# **Pearl Place Buildings 1 & 2**

**ADDENDUM IV**

**October 11, 2006**

## **Addendum #4**

#### **A4.2 Wall Sections**

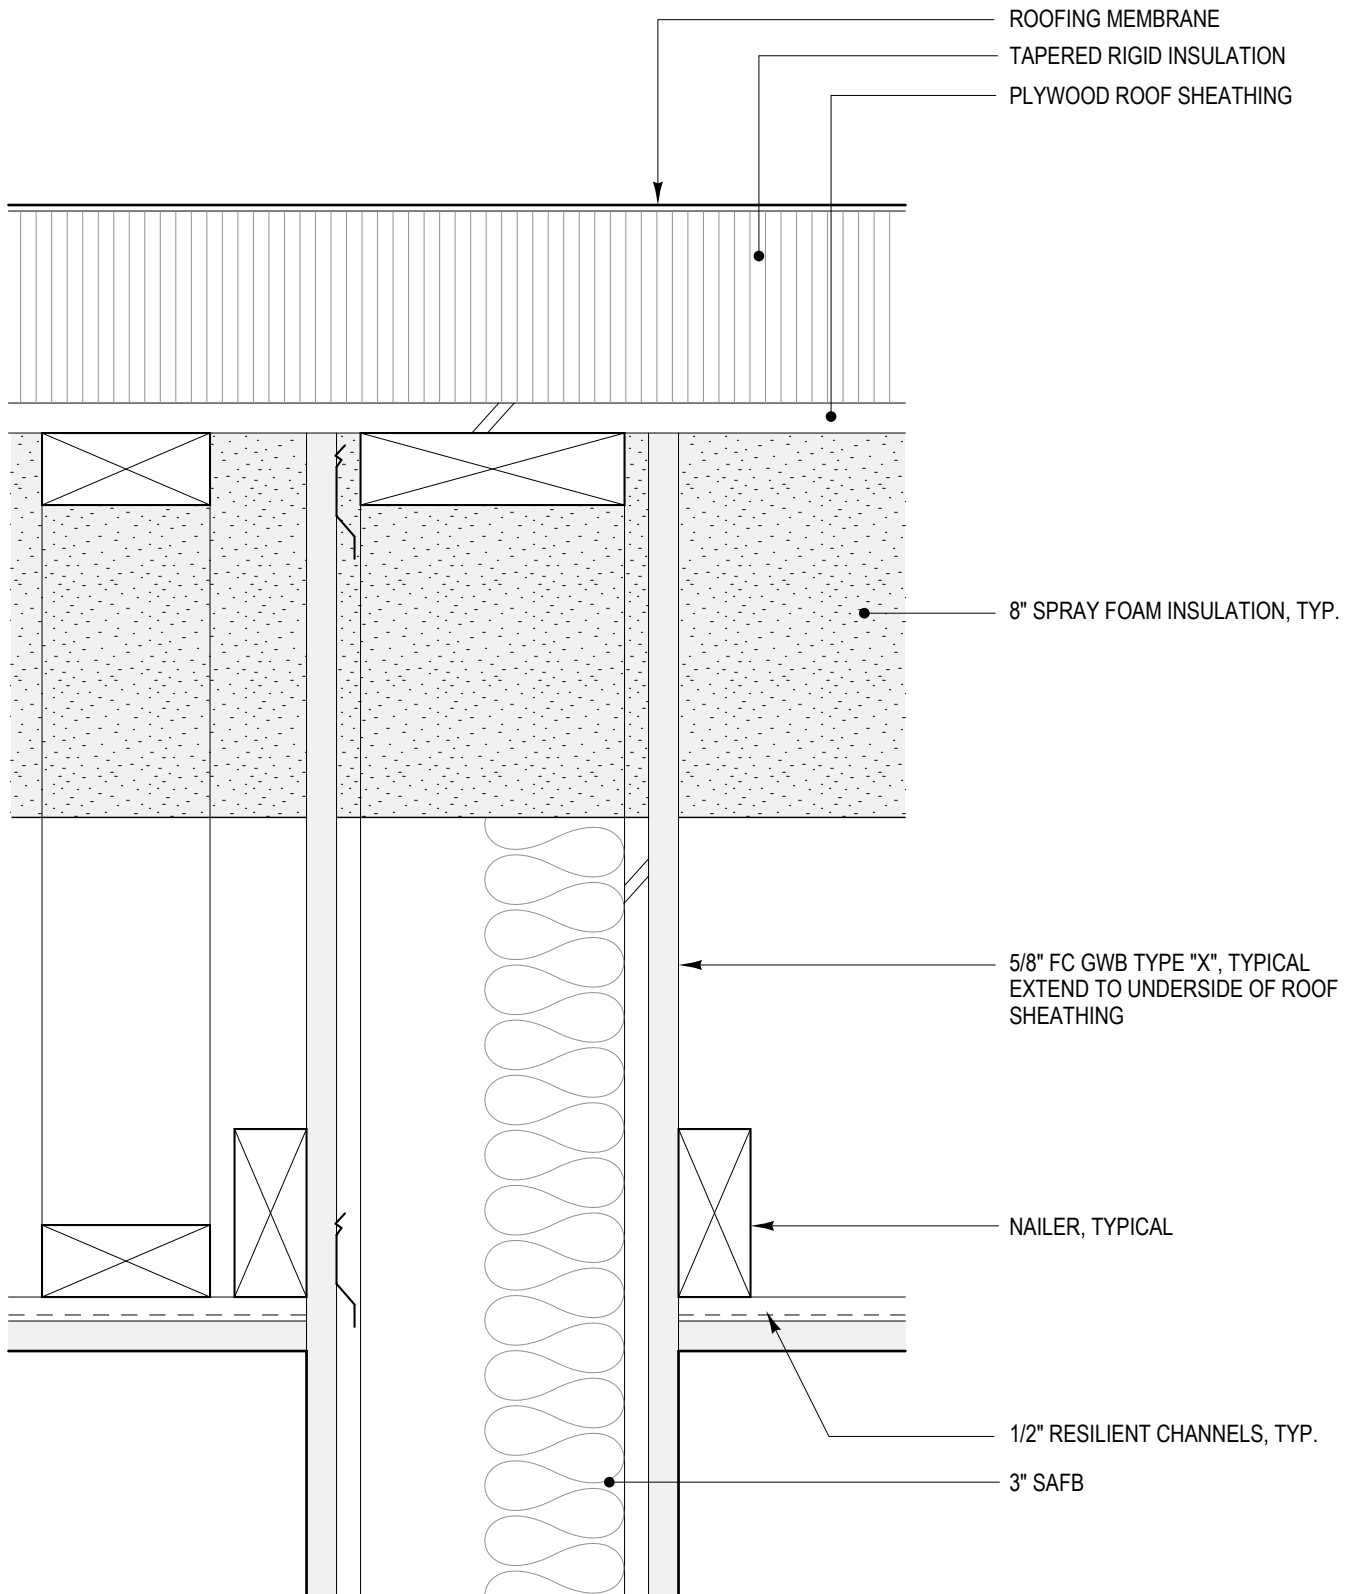
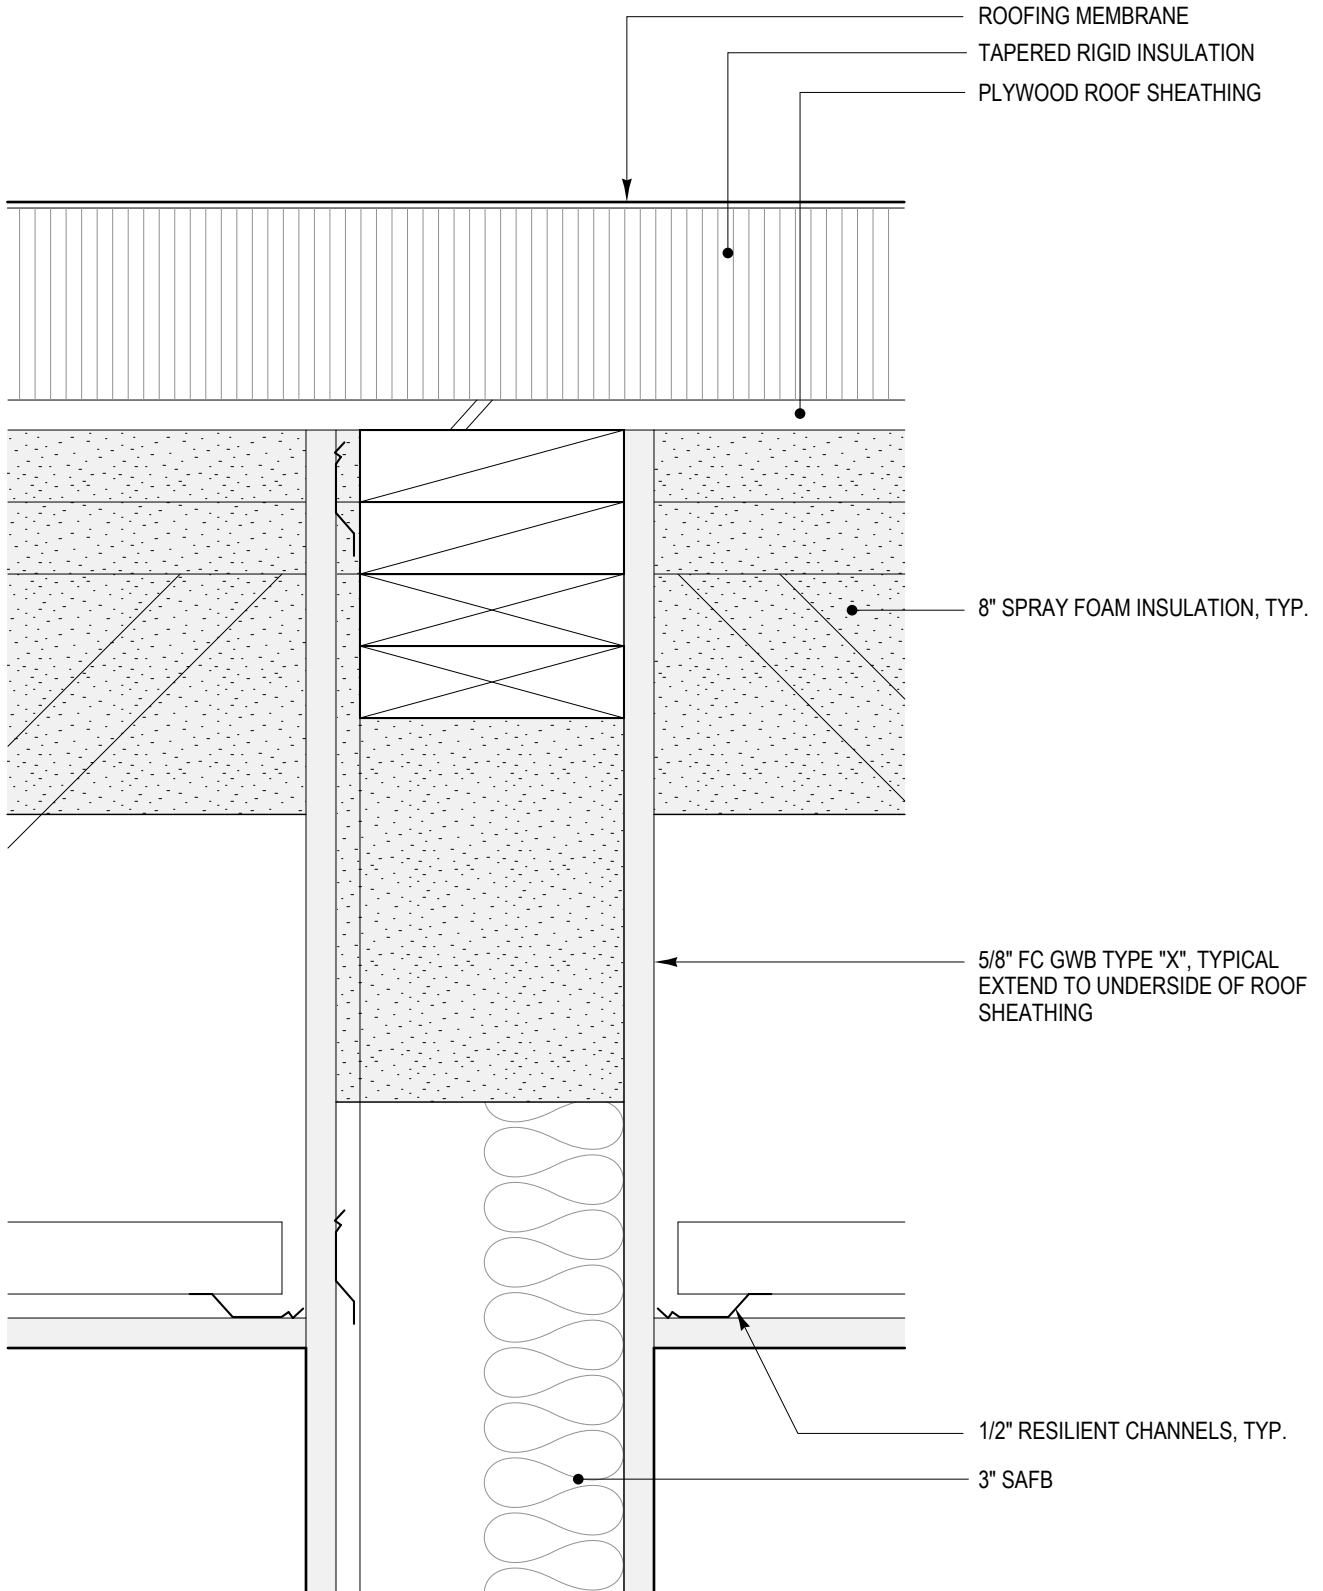
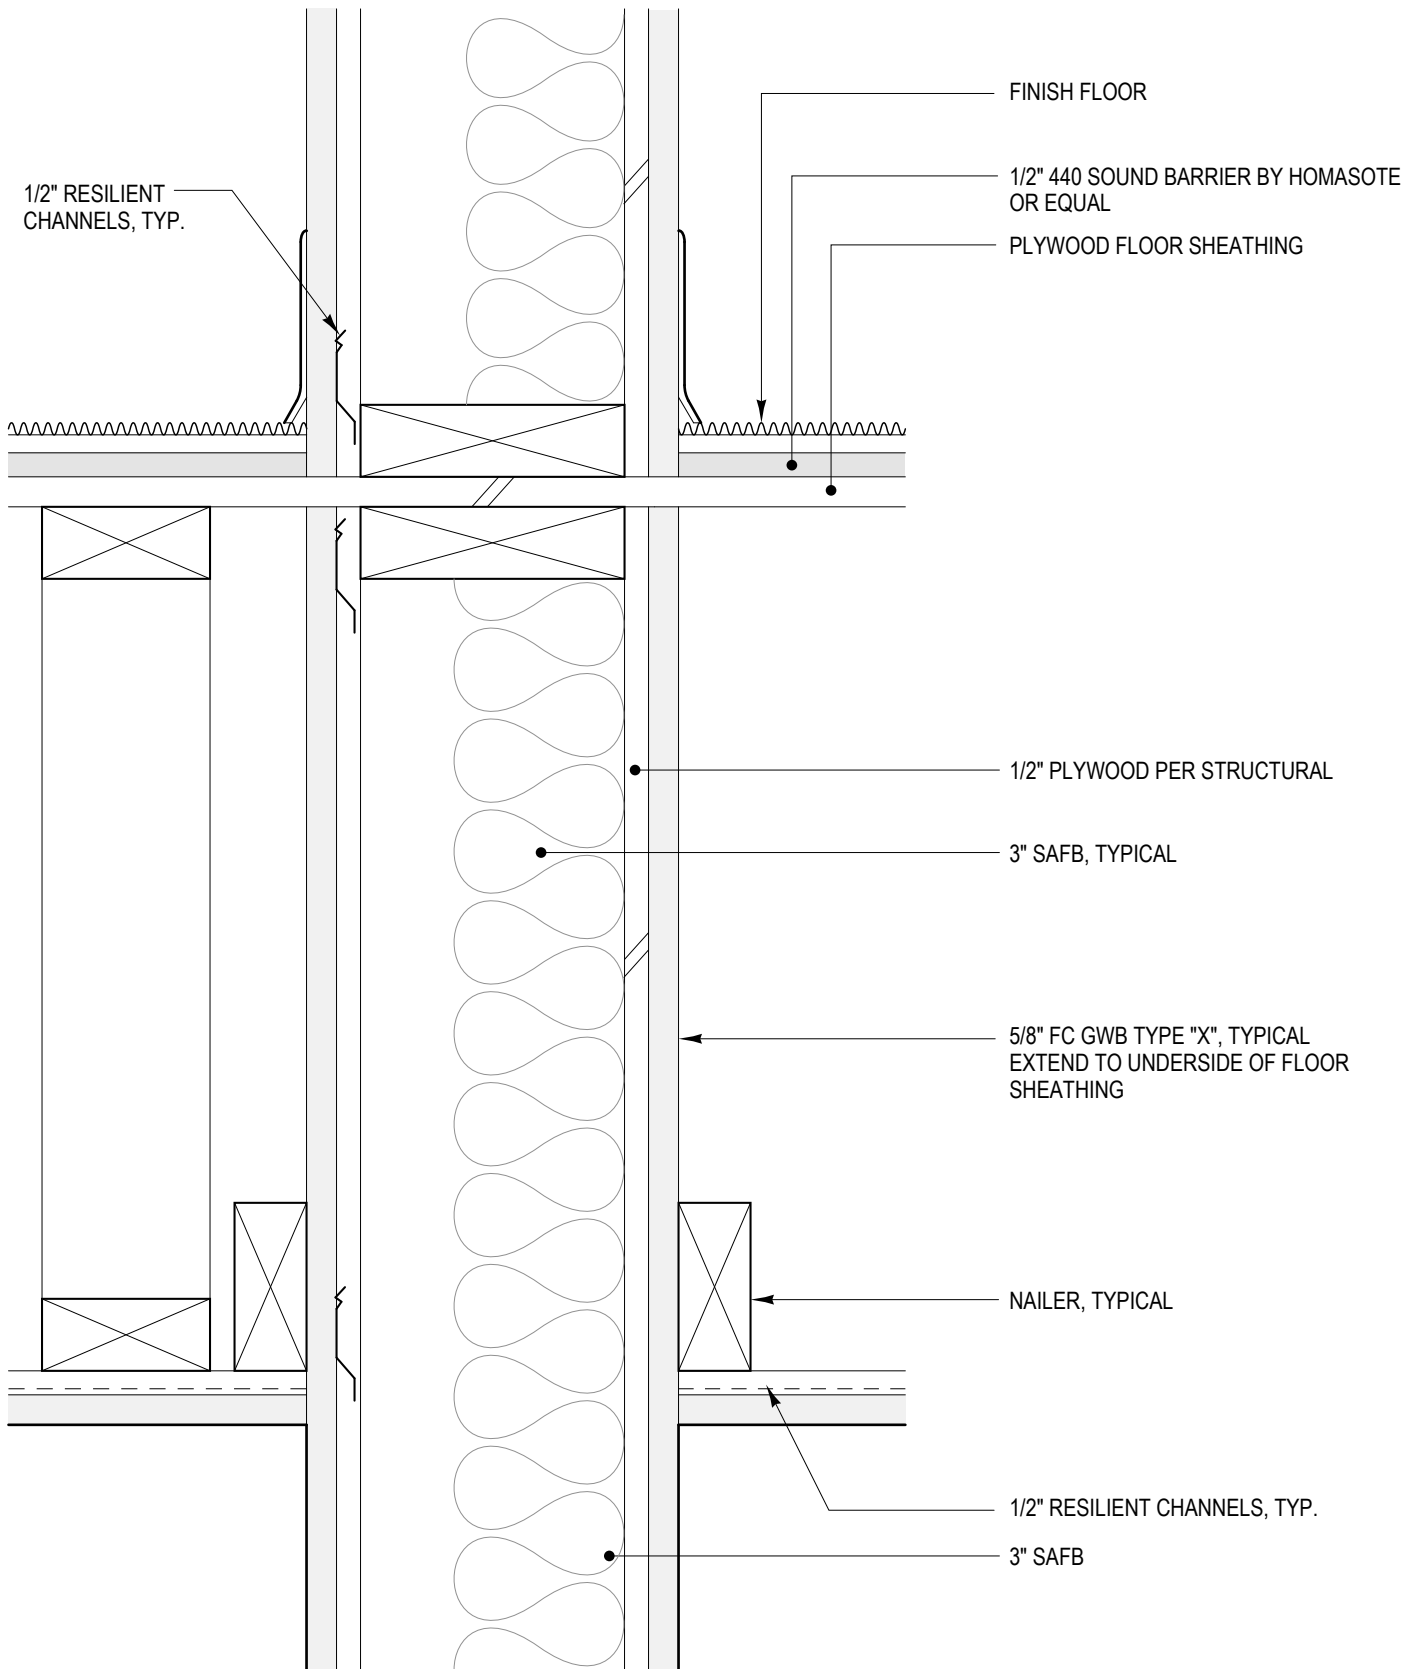
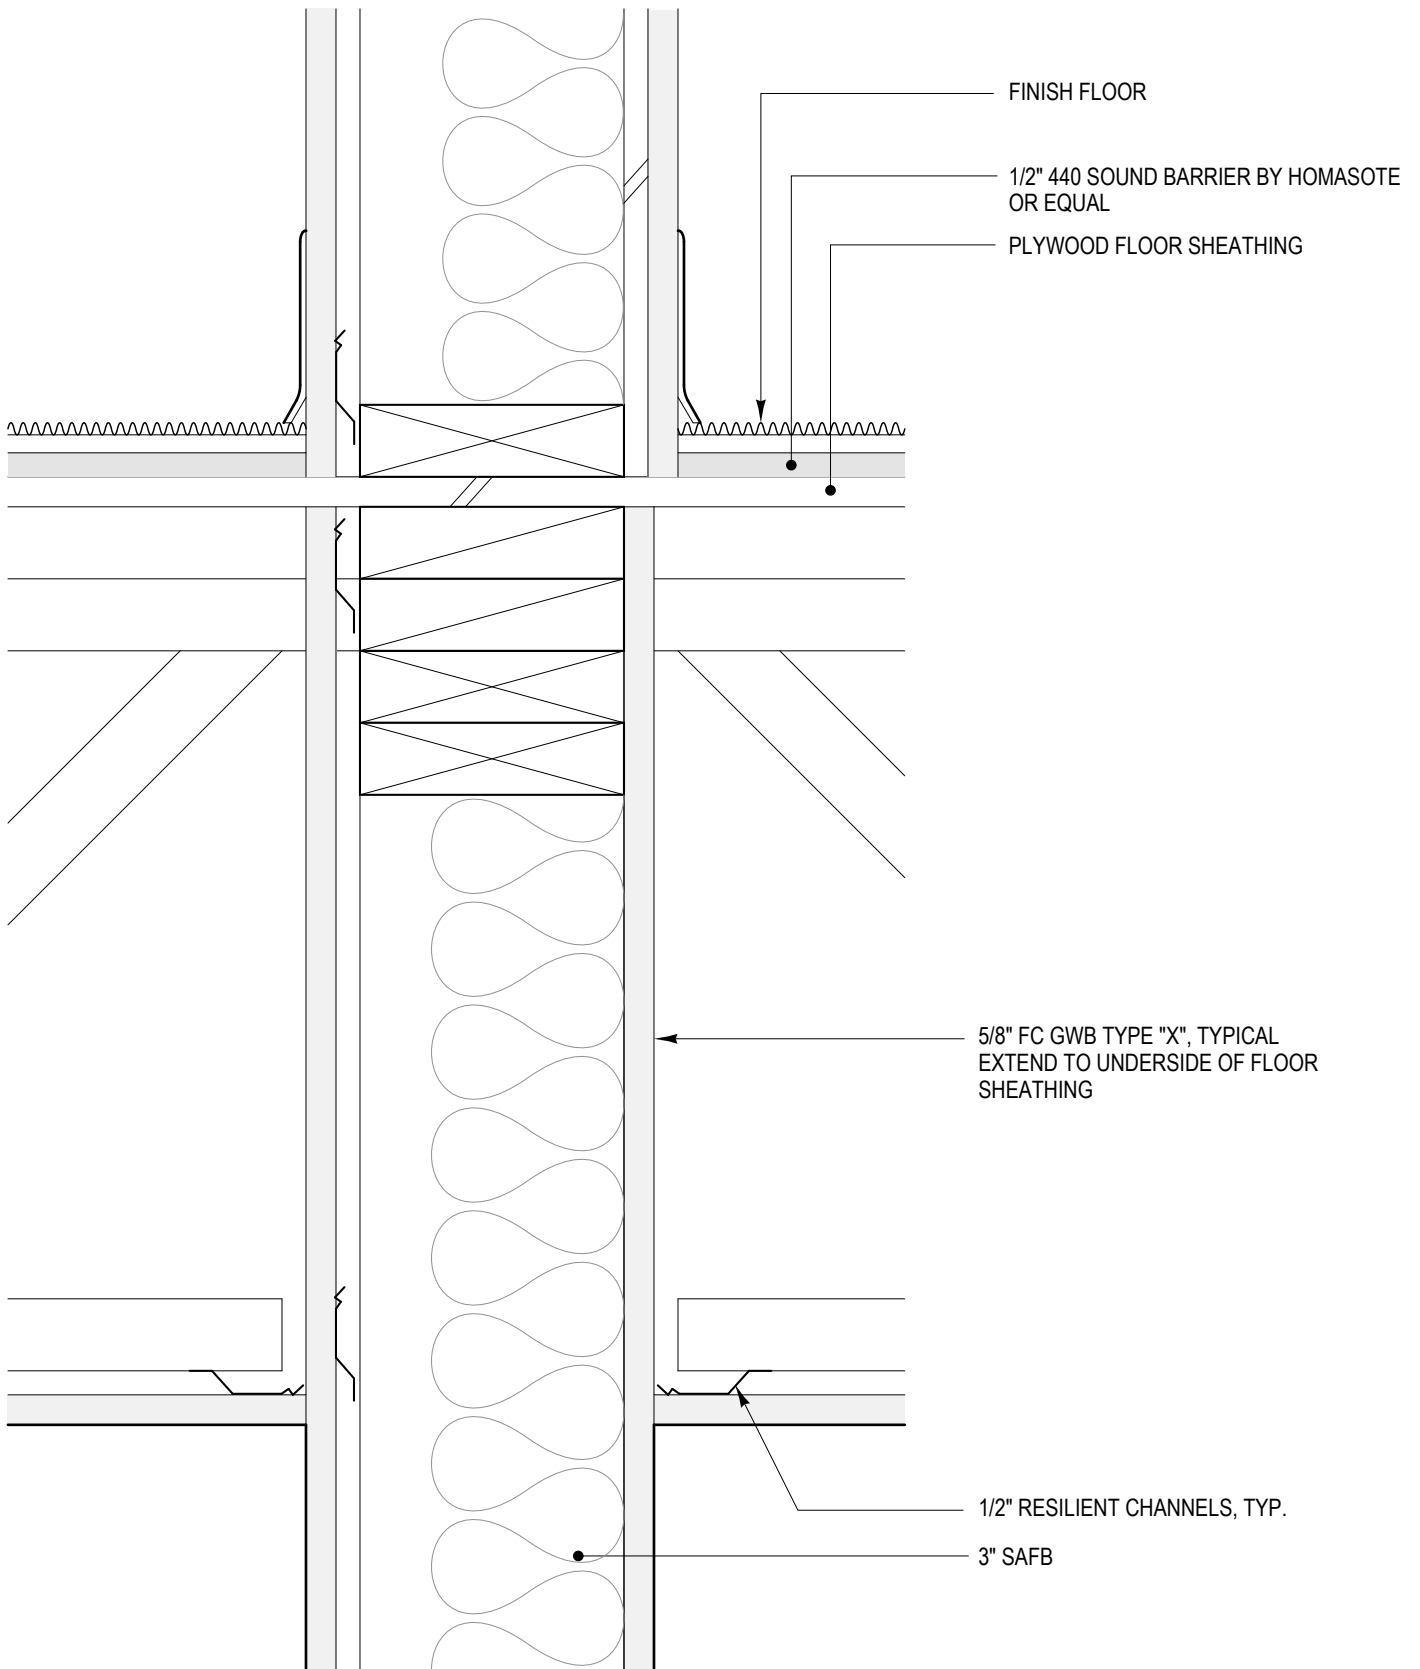
See clarification details on ASK 10 for party wall penetrations and top of party wall as shown on Section 5.
